**TECHNICON DESIGN GROUP INC.**

DATE: OCTOBER 4, 2018**PROJECT NUMBER:** 72-2351-17**PROJECT NAME:** HEALTH PARTNER OF WESTERN OHIO - TIFFIN COMMUNITY HEALTH CENTER**INTENT:**

This Addendum provides modifications and clarifications To the Bid Documents dated **08/23/2018**. Bidder shall ascertain prior to submitting its Bid Form that it has received all Addenda issued and shall acknowledge receipt of each Addendum on the Bid Form.

END OF ADDENDUM 02

SHEET
 E100
 OF SHEETS

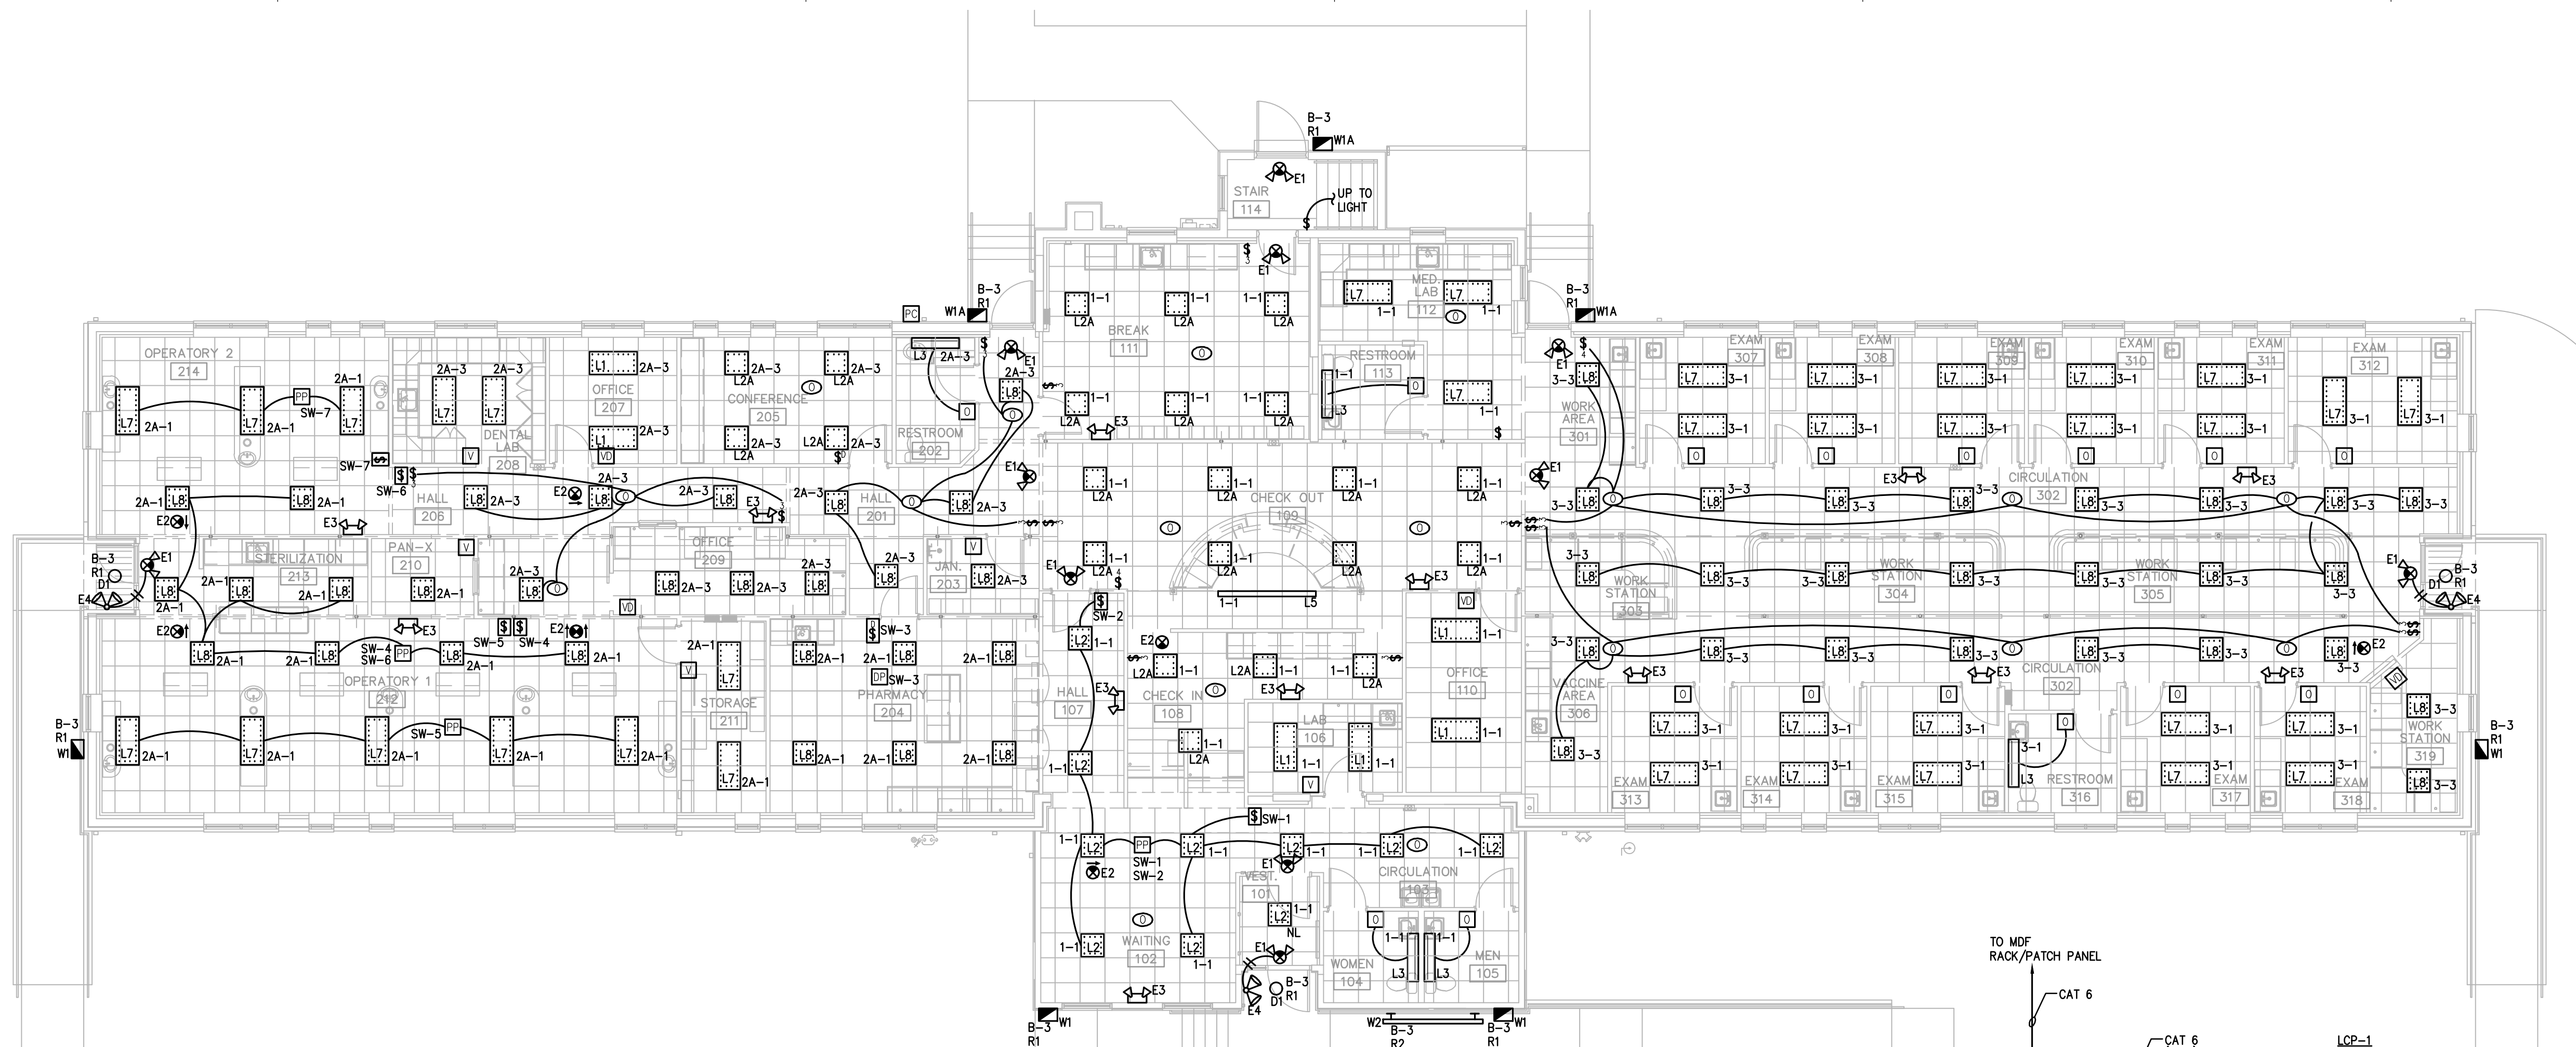
19		M400	Mechanical Specifications Section 2.02 Ductwork & Accessories Part D: In lieu of "spiral lockseam" duct, substitute "longitudinal seams" for all round ductwork fabrication.
20		M400	Mechanical Specifications Section 3.05 Power Ventilators, Part B Manufacturers Add: Johnson Controls/Penn-Barry as acceptable manufacturers.
21		M400	Mechanical Specifications Section 3.08 VVT Dampers, Part A Add: Johnson Controls as an acceptable manufacturer.
ELECTRICAL:			
22	E100 09-27-18 ADDENDUM 02		PLAN SYMBOL LEGEND: Receptacle descriptions have been revised to require <u>all</u> receptacles to be Tamper-Resistant. See revised drawing sheet.
23	E300 09-27-18 ADDENDUM 02		Added circuit numbers to basement light fixtures. See revised drawings sheet.
24	E401 09-27-18 ADDENDUM 02		Remove "TR" (Tamper-Resistant) designation from receptacles in Waiting 102. <u>All</u> receptacles will now be Tamper-Resistant per revisions to Plan Symbol Legend on sheet E100. See revised drawing sheet.

E402

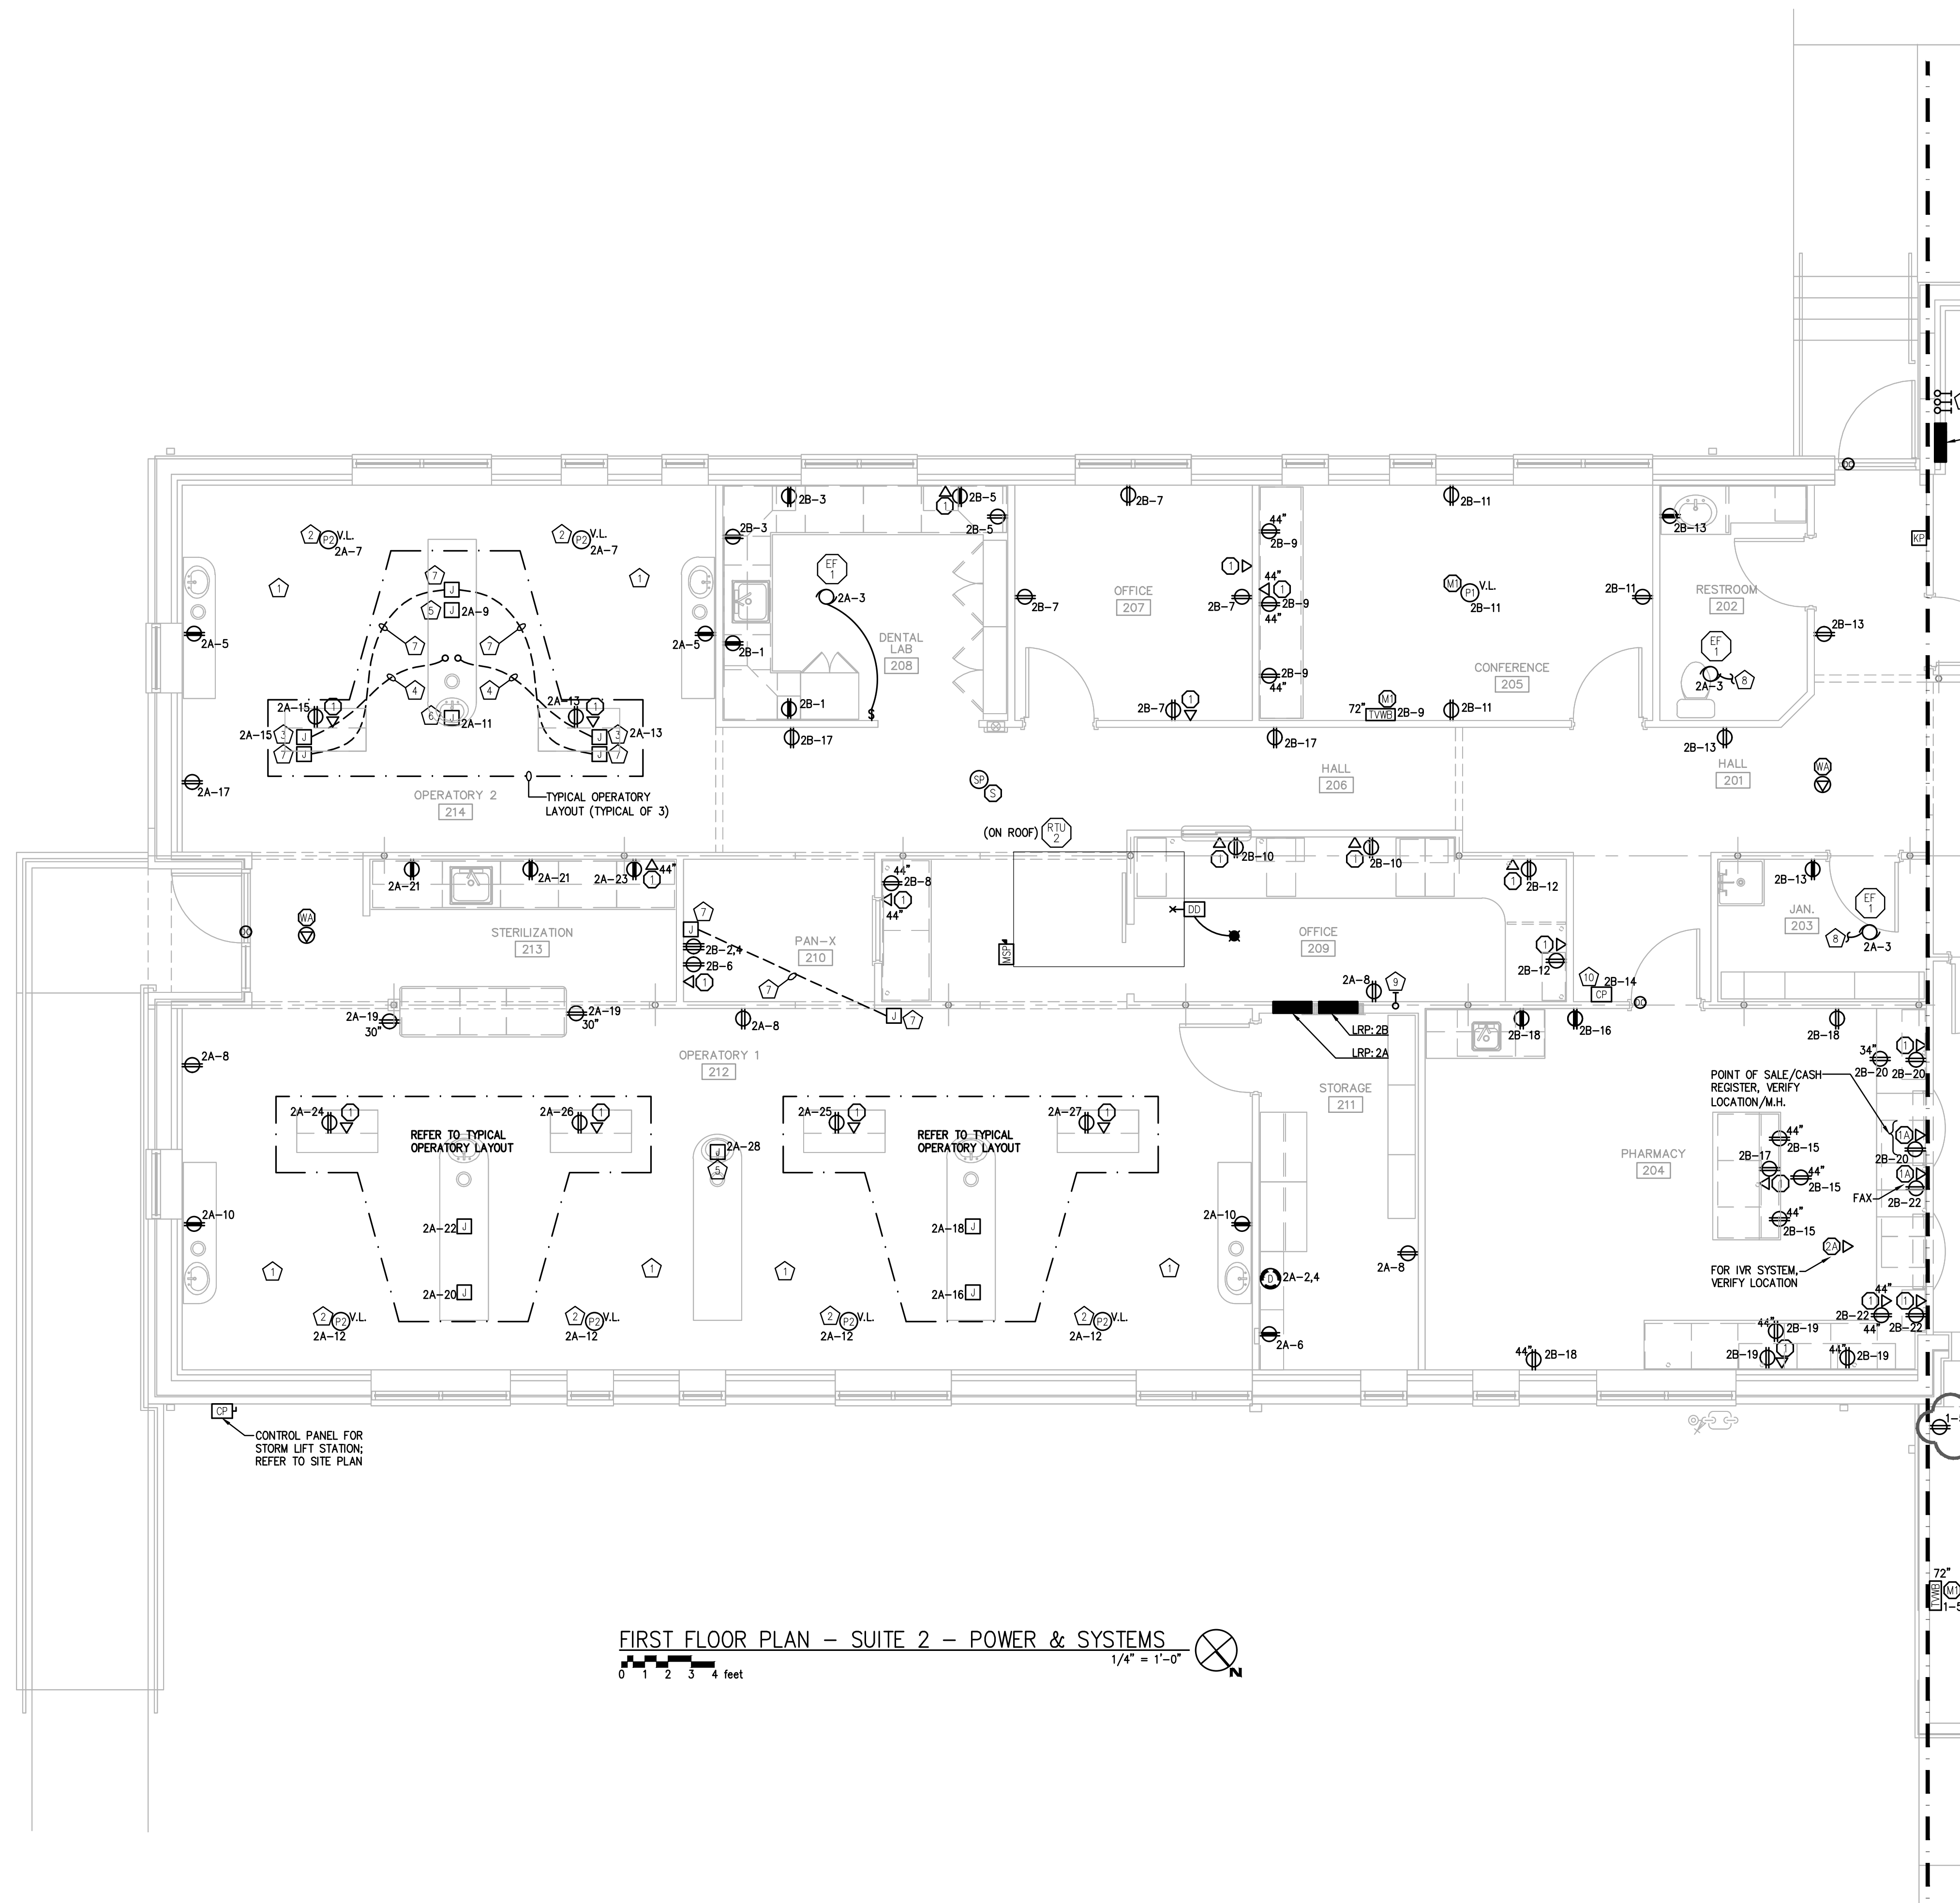
25	E401, E402, E403 09-27-18 ADDENDUM 02		Refer to sheet M400 Mechanical Specifications, Part 3.04, D, Accessories, Item #6: Provide power for unit mounted, factory wired GFCI, receptacles as required.
26	E401, E402, E403 09-27-18 ADDENDUM 02		FLOOR PLAN NOTES: Note #1; Revise 517.3 to 517.13. See revised drawing sheet.
27	E500 09-27-18 ADDENDUM 02		Added basement lighting circuits to Panel LRP:B panel schedule. See revised drawing sheet.
